CUYAMA BASIN GROUNDWATER SUSTAINABILITY AGENCY STANDING ADVISORY COMMITTEE

Cuyama Basin Groundwater Sustainability Agency

Groundwater Sustainability Plan Update

Figure 2.2-12: Cuyama GW Basin Hydrographs for the Ventucopa Area of the Basin
 Cuyama Basin Groundwater Sustainability Agency
 Cuyama Valley Groundwater Basin Groundwater Sustainability Plan
 August 2018

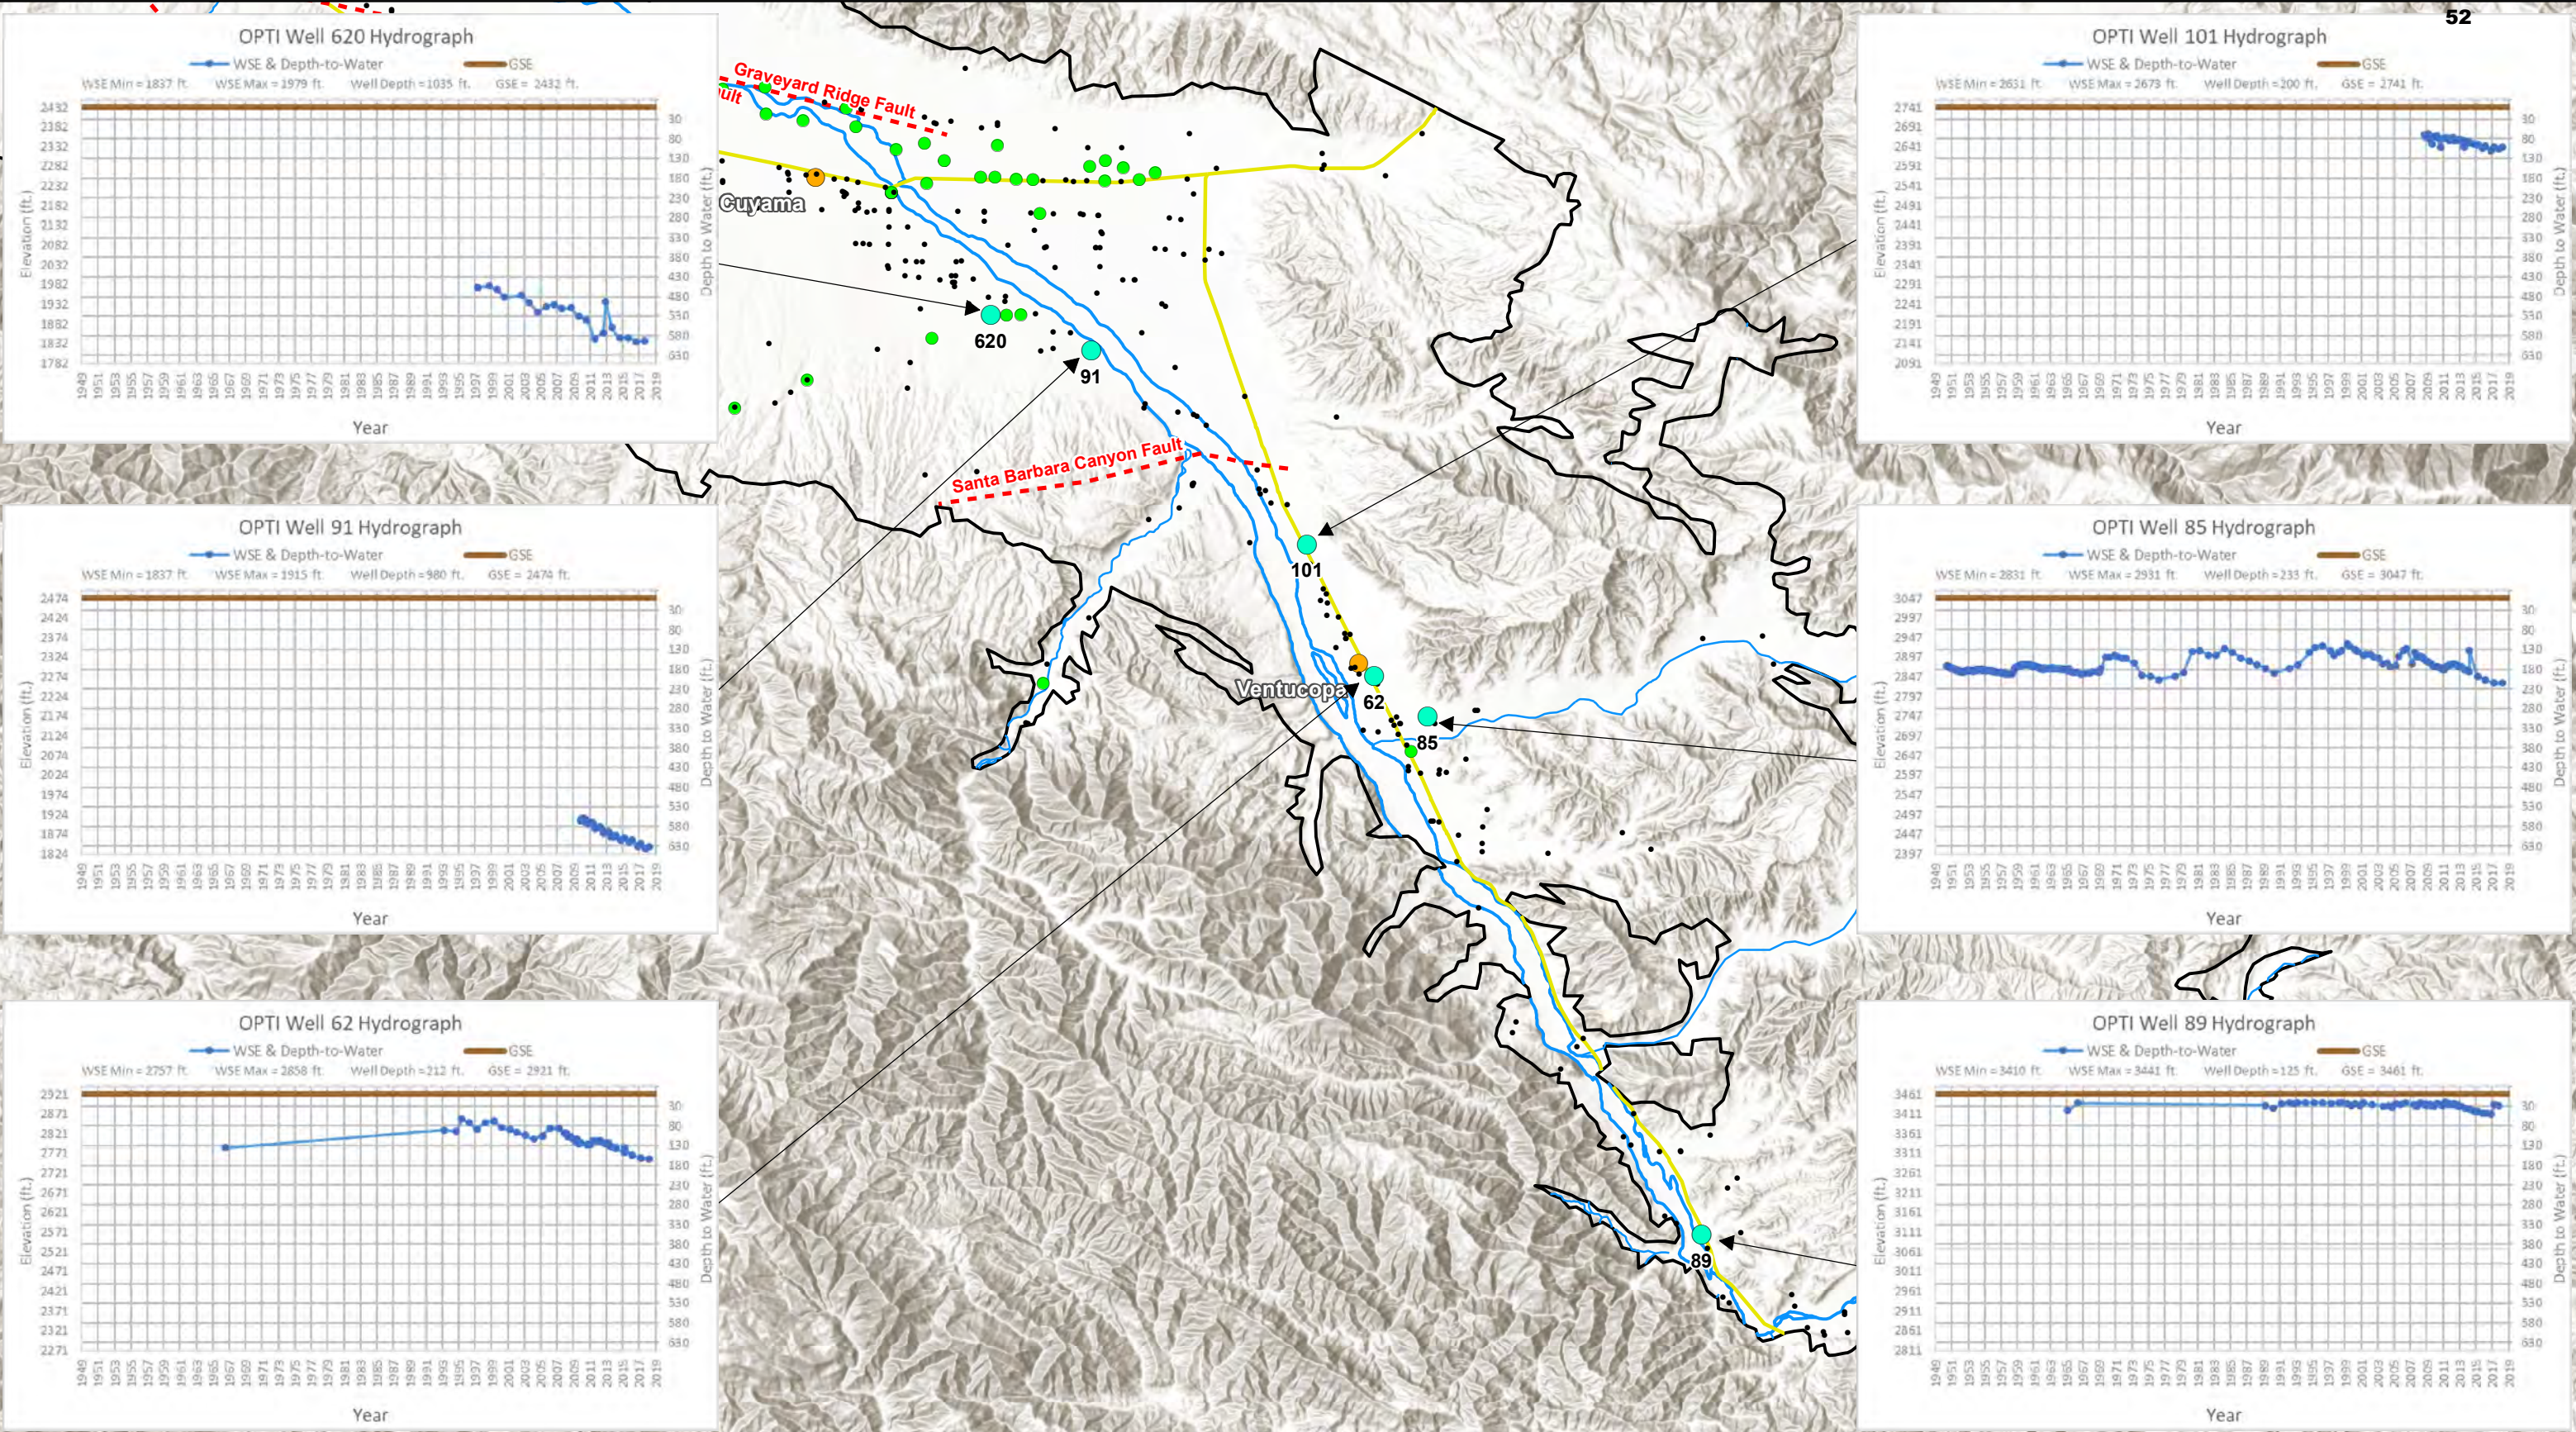
146	Matt Young, Matt Scudato, & Fray Crease	Santa Barbara County Water Agency	2.2.3 GW Hydrographs			Figure 2.2-12 shows selected hydrographs	Why is this section in a different format than the previous. Please make consistent.	Comment noted. No change needed.
147	Matt Young, Matt Scudato, & Fray Crease	Santa Barbara County Water Agency	Figure 2.2-12				Well 40 & 316 - where? Not shown in map	The text has been revised for clarity.
148	Matt Young, Matt Scudato, & Fray Crease	Santa Barbara County Water Agency	2.2.3 GW Hydrographs			Figure 2.2-13 shows hydrographs of discontinued monitoring wells	Then need to explain why they were selected.	The text has been revised for clarity.
149	Matt Young, Matt Scudato, & Fray Crease	Santa Barbara County Water Agency	General				Stick with one descriptor – either elevation or depth to water. Mixing elevation and depth to water is confusing to the reader.	The section consistently discusses depth to water

Figure 2.2-20: Cuyama GW Basin Wells by Depth to Water
 Cuyama Basin Groundwater Sustainability Agency
 Cuyama Valley Groundwater Basin Groundwater Sustainability Plan
 August 2018

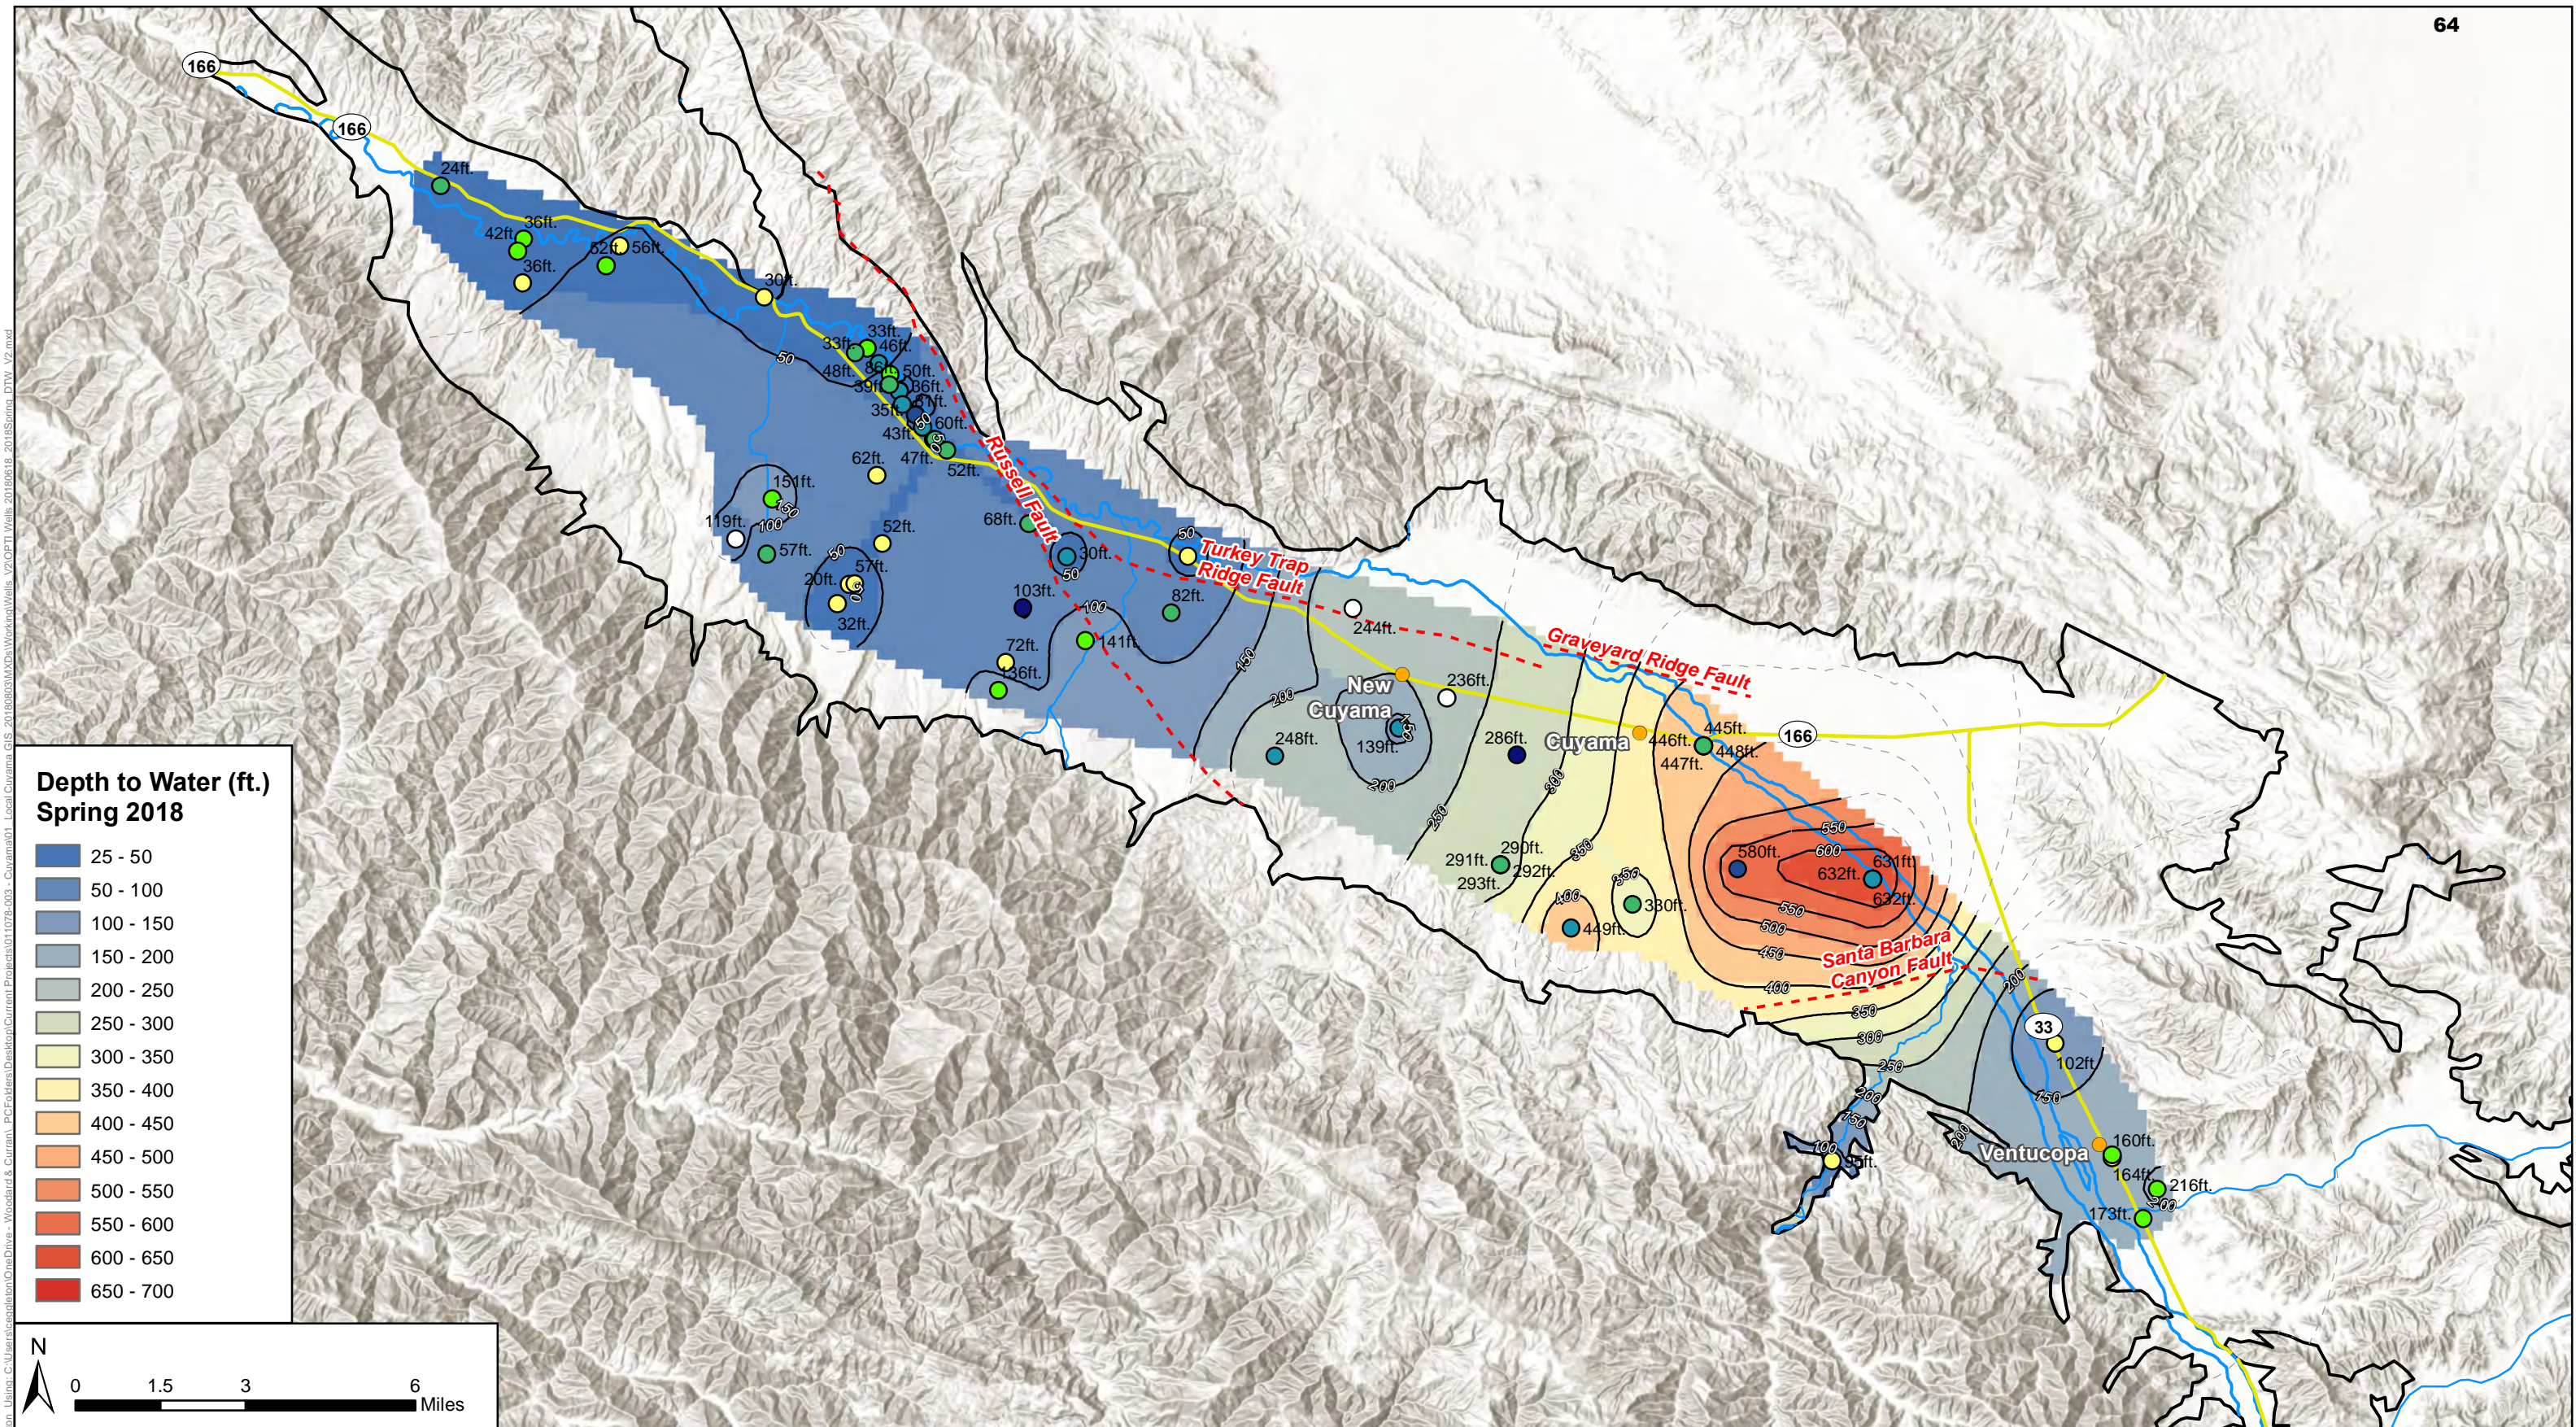
8	Brenton Kelly	Quail Springs Permaculture	2.2.3	N/A	N/A	Fig. 2.2-20	Illustrates a classic example of a Bullseye depression. Speak to the significance of these conditions. Speak also to the Data Gaps representing the missing northeast area, near the intersections of 166 & 33. How big or deep is the zone of depression?	Comment noted. The document notes that the depth to water is up to 600 feet deep.
9	Brenton Kelly	Quail Springs Permaculture	2.2.4	1	N/A	Bullet #1	Storage loss is a significant groundwater condition that should be measurable, but we are going to model it first. The cart is before the horse!	While changes in groundwater storage can be inferred from changes in groundwater levels, storage quantities cannot be directly measured with the available data. The numerical model will provide the best available estimate of groundwater storage.
10	Brenton Kelly	Quail Springs Permaculture	2.2.6	2	1	Subsidence	Subsidence at a rate of > 0.5" / year should not be dismissed or diminished by comparison to the collapse of the San Joaquin. This is a critical Data Gap with only one monitor site in the central basin. It may or may not be anomalous without anything to compare it to	Comment noted. The need for additional subsidence monitoring is discussed in the Monitoring Networks section.
